# United States Patent and Trademark Office

APPLICATION NO.	FILING DATE	FIRST NAMED INVENTOR	ATTORNEY DOCKET NO.	CONFIRMATION NO.
10/797,463	03/10/2004	Kyoung-Hwan Yeo	5649-1238	4432
20792 7590 11/15/2007 MYERS BIGEL SIBLEY & SAJOVEC PO BOX 37428			EXAMINER	
			STARK, JARRETT J	
RALEIGH, NC 27627			ART UNIT	PAPER NUMBER
			2823	
				-14,
			MAIL DATE	DELIVERY MODE
			11/15/2007	PAPER

#### **DETAILED ACTION**

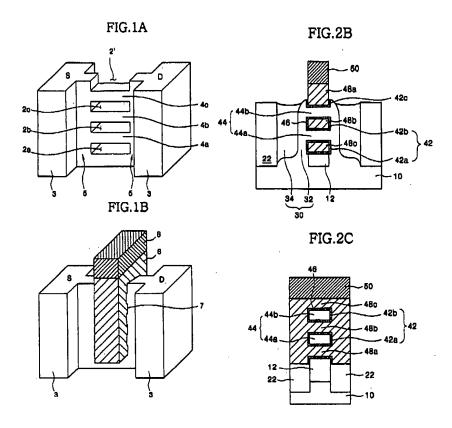
Regarding claims 12 - 30, <u>Kim et al. 3</u> discloses a method of forming a unit cell of a metal oxide semiconductor (MOS) transistor, comprising:

forming a MOS transistor on an integrated circuit substrate including an isolation layer and an active region higher than the isolation layer, the MOS transistor having a source region and a drain region on the isolation layer, and a plurality of gates on the active region, the plurality of gates being stacked between the source region ant the drain region (Kim, Figurs 1A, 1B, 2B and 2C);

forming a horizontal channel between the source and drain regions, the horizontal channel including at least two horizontal channel regions formed in spaced apart patterns, wherein the source and drain regions are vertically formed to cover the sides of the active region in other patterns adjacent to sides of the spaced apart patterns (Kim, Figurs 1A and 1B);

FIG. 30

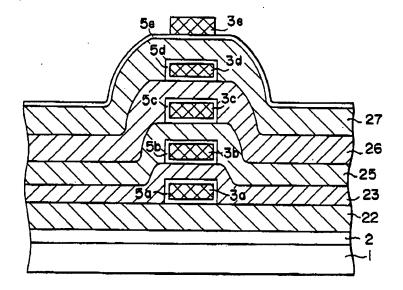
Regarding claims 12 and 30, Maegawa discloses a method of forming a unit

cell of a metal oxide semiconductor (MOS) transistor, comprising: forming a MOS transistor on an integrated circuit substrate including an isolation layer (fig. 30 layer 2) and an active region higher than the isolation layer (Fig. 30, layers 3a, 3b, 3c, 3d, 3e,...), the MOS transistor having a source region and a drain region (not shown due the cross-sectional view of figure 30, however source and drains are inherently required to be adjacent either side of each channel. A channel can not function without a source and drain) on the isolation layer, and a plurality of gates on the active region, the plurality of gates being stacked (Fig. 30, layers 22, 23, 25, 26, 27,...) between the source region ant the drain region (not shown due the cross-sectional view of figure 30, however source and drains are inherently required to be adjacent either side of each channel. A channel can not function without a source and drain);

forming a horizontal channel between the source and drain regions, the horizontal channel including at least two horizontal channel regions formed in spaced apart patterns (Fig. 30), wherein the source and drain regions are vertically formed to cover the sides of the active region in other patterns adjacent to sides of the spaced apart patterns (not shown due the cross-sectional view of figure 30, however source and drains are inherently required to be adjacent either side of each channel. A channel can not function without a source and drain)

Regarding claim 17, Maegawa discloses the method of claim 16, further comprising: forming a gate pattern (Fig 30-[26]) on the horizontal channel (Fig 30-[3c]) and between the at least two spaced apart horizontal channel regions (Fig 30-[3c and 3d]); and forming a gate insulation layer (Fig 30-[5c and 5d]) between the gate pattern and the at least two spaced apart horizontal channel regions.

FIG. 15

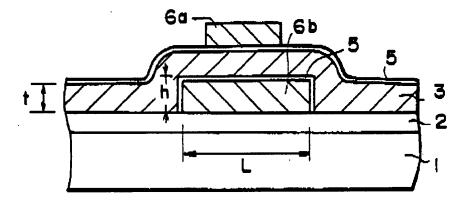
Regarding claim 16, Maegawa discloses the method of claim 12, wherein forming the source and drain regions comprises forming vertical source and drain regions, the vertical source region being on a first side of the horizontal channel region and the vertical drain region being on a second side of the horizontal channel region and spaced apart from the vertical source region (Fig 15 & Col. 6 lines 53-57).

forming a first insulation pattern (Fig 15. – insulation layers [2] and/or [5]) between the source and drain electrodes and the integrated circuit substrate and between the gate pattern and the integrated circuit substrate.

Regarding claim 20, <u>Maegawa</u> in view of <u>Nakajima</u> discloses the method of claim 19, further comprising: forming a second insulation pattern (Fig. 15 – [5]) on the horizontal channel and the vertical source and drain regions (Fig. 15 – [3] – source and

drain regions left and right of gate 6a), wherein the second insulation pattern defines a gate opening on the horizontal channel (Fig. 15 – circled by Examiner for clarity), wherein the gate pattern is provided in the gate opening and

Regarding claim 22, <u>Maegawa</u> in view of <u>Nakajima</u> discloses the method of claim 21, wherein an upper surface of the first insulation pattern is higher relative to a lower surface of the gate pattern. (<u>Maegawa</u>, Fig. 15 first insulating layer [5] is above lower gate pattern [6b])

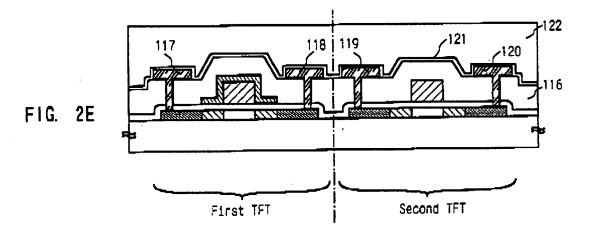
Maegawa does not explicitly disclose wherein the source and drain electrodes extend through the second insulation pattern and are connected to the vertical source drain regions. It is however notoriously well known extend the source and drain electrodes through the insulation pattern to make electrical contact with the source and drain electrodes. An example of this is shown by <a href="Nakajima">Nakajima</a> in Figure 2E below. The figure shows a commonly used method of connecting source and drain electrodes to the source and drain trough an insulating layer.

forming source and drain electrodes penetrating the second insulation pattern to be connected to the third epitaxial layer (Nakajima, Figure 2E).
